**AGENDA**  
**MANOR PLANNING AND ZONING COMMISSION**  
**105 E. EGGLESTON ST.**  
**MANOR, TEXAS 78653**  
**APRIL 13, 2016 6:30 P.M.**

Re: First Construction Plan and Final Plat Review for  
Shadowglen Phase 2, Section 20 Subdivision  
City of Manor, Texas

Re: Master Plan Review for  
Lagos PUD  
City of Manor, Texas

Re: Master Plan Second Review for  
Lagos PUD  
City of Manor, Texas

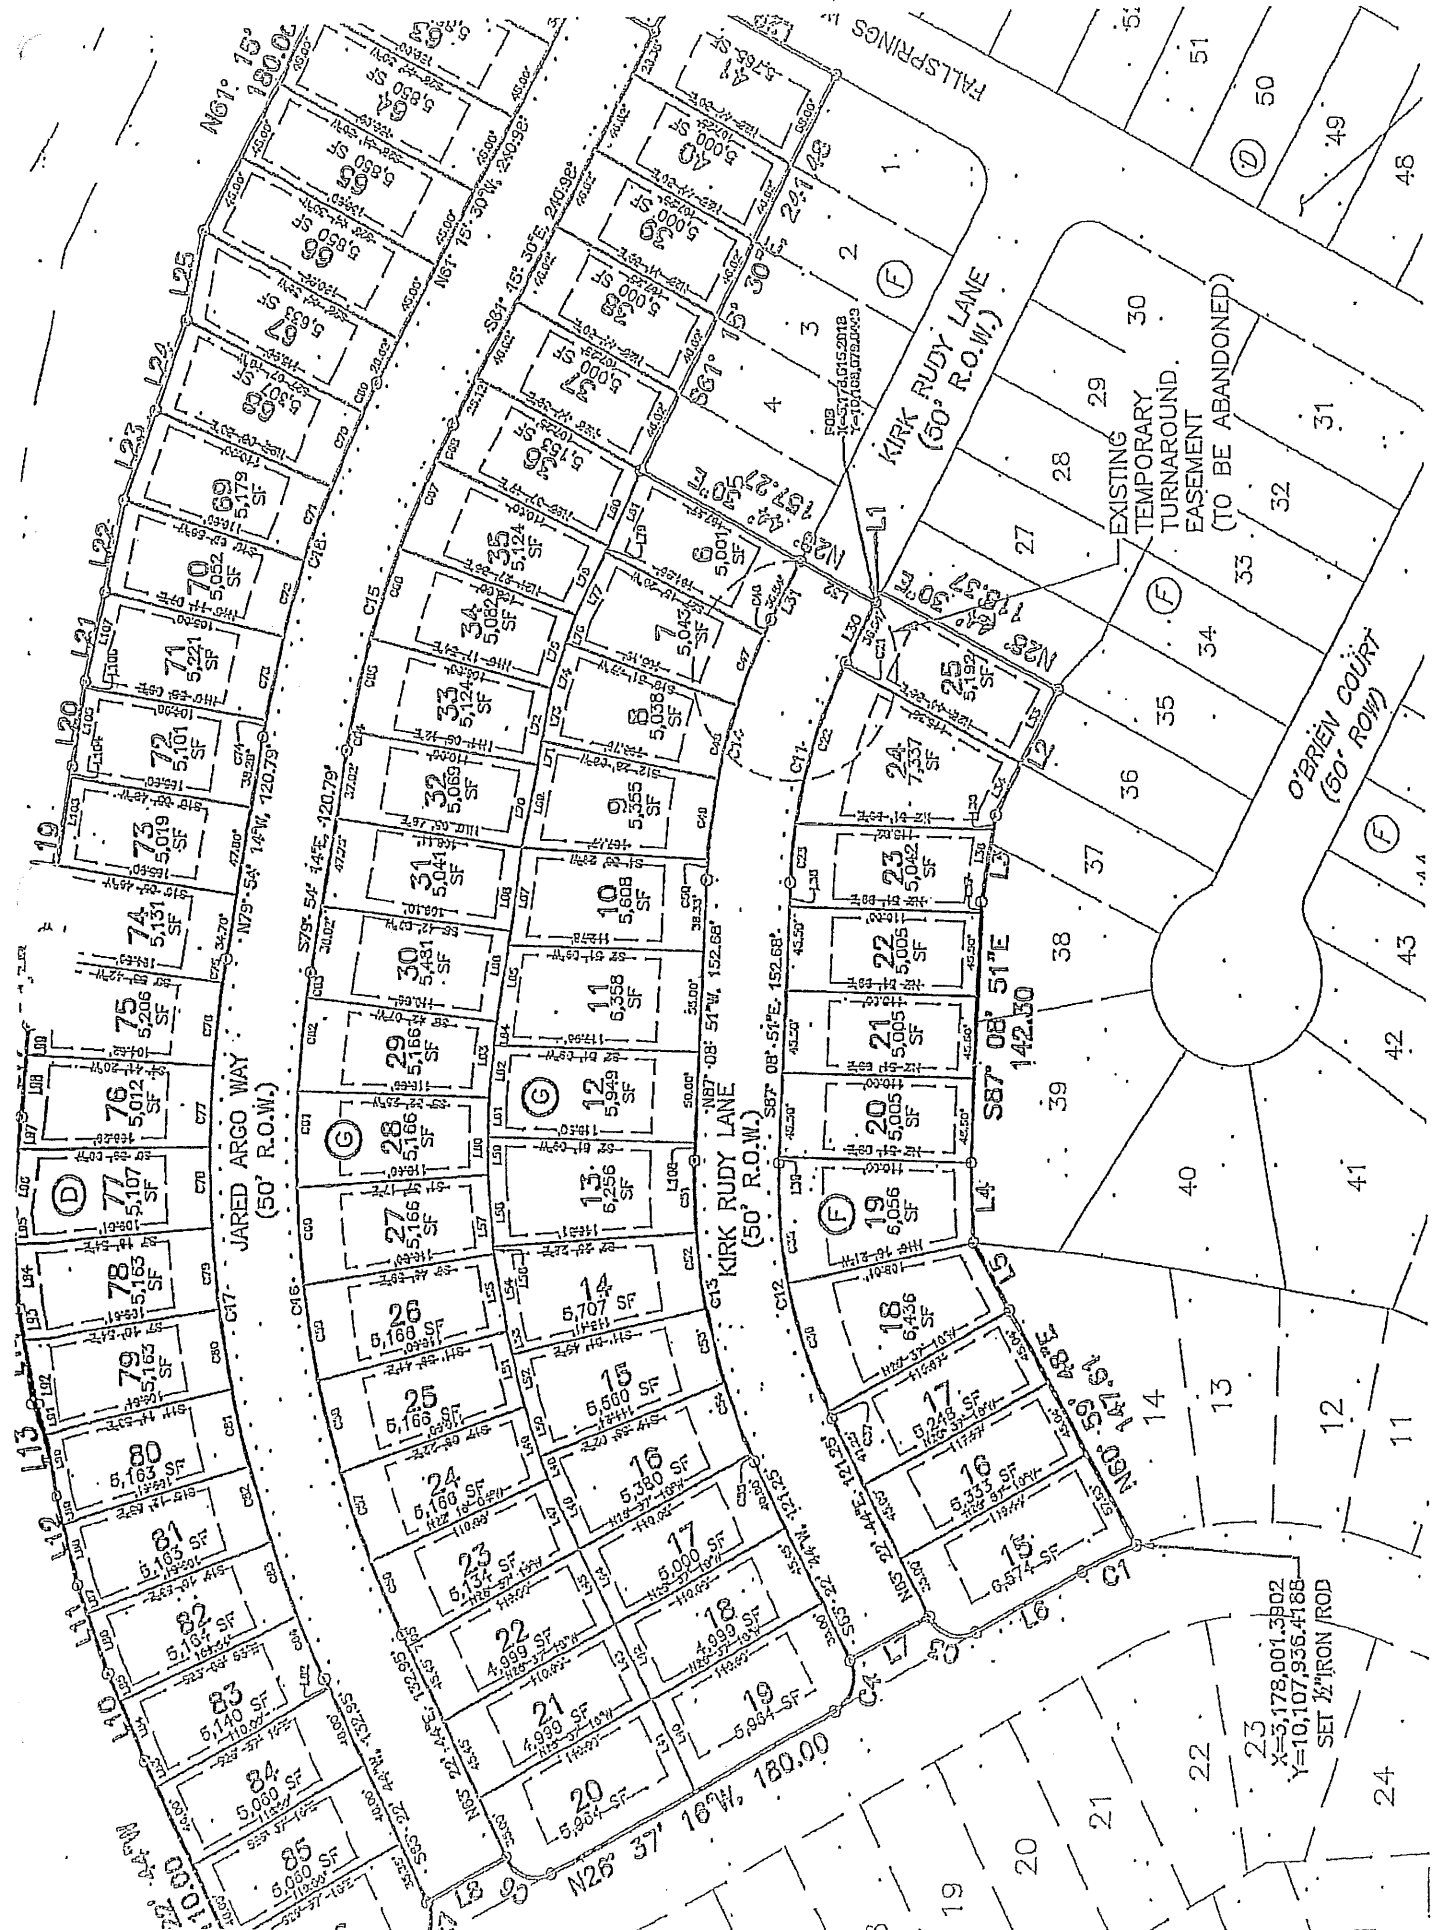
1. Provide Geotechnical Engineering Report and Pavement Design for all proposed streets and include a table or detail of proposed pavement section for each street.
2. FYI - the AARV detail should be updated to utilize the City of Manor modification or City of Austin Standard that utilizes PE pipe rather than copper tubing.
3. Include the final plat in the plans.
4. Provide benchmarks on plat and/or plans.
5. The submitted tax certificates show taxes paid for 2013 and Delinquent taxes from prior years. Tax certificates must be submitted showing all taxes paid as required in Section 24(d)(2)(v) of Subdivision Ordinance 159.

1. Provide Geotechnical Engineering Report and Pavement Design for all proposed streets and include a table or detail of proposed pavement section for each street.

2. FYI – AARV detail should be updated to utilize the City of Manor modification or City of Austin Standard that utilizes PE pipe rather than copper tubing.

**Response: Geotechnical Engineering Report prepared by Terracon and dated November 2012 is attached for your reference. Additionally, a table showing the proposed pavement section has been included on Sheet C523.**

**Response: The AARV detail in sheet C531 has been updated to show the City of Manor modification.**

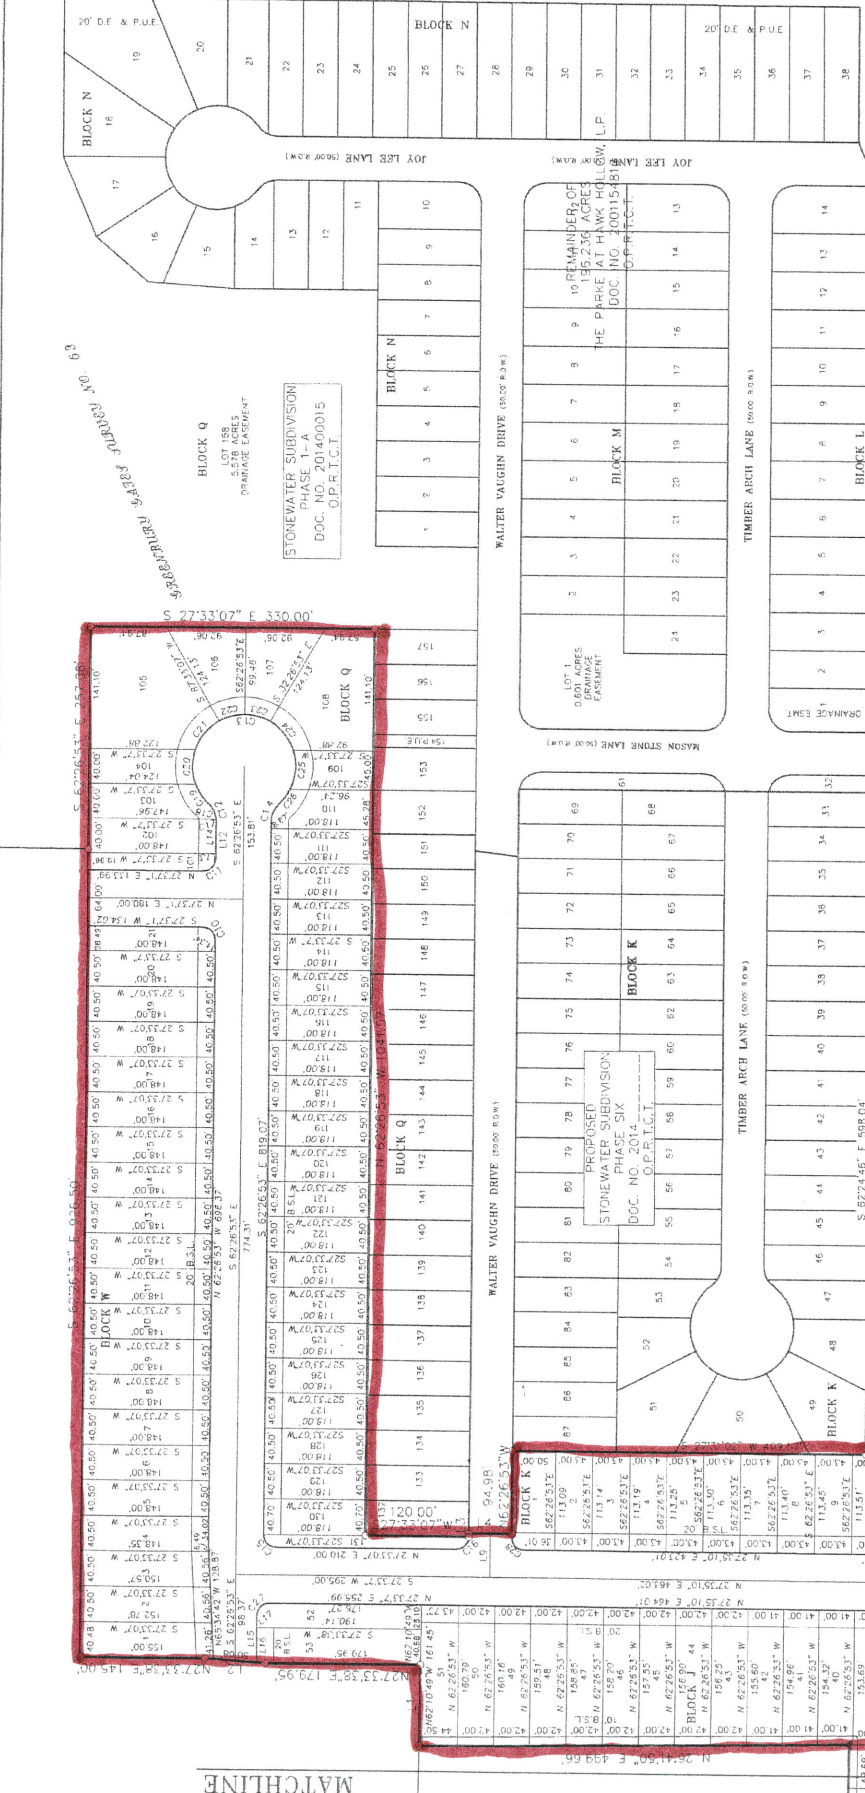
1. The year on signature blocks should be revised to 2016.
2. The City of Manor city secretary and mayor names are incorrect on the plat.
3. Proposed landscaped lots should be identified on the plat.
4. The proposed location of sidewalks for each street should be shown on the plat.
